Modifications to BW16 rtlduino v1.0 to be able to download from Arduino using on board USB

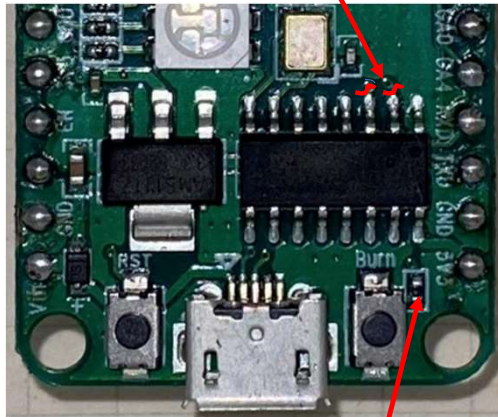
Add jumper from CH340 pin 3 to PA7 (LOG_TX)

Add Jumper from CH340 pin 2 to PA8 (LOG_RX)

Cut traces to Pins 2 and 3 of CH340

Change resistor from 0 ohms to 1.8K to meet RTL872X requirements for the minimum resistance to ground
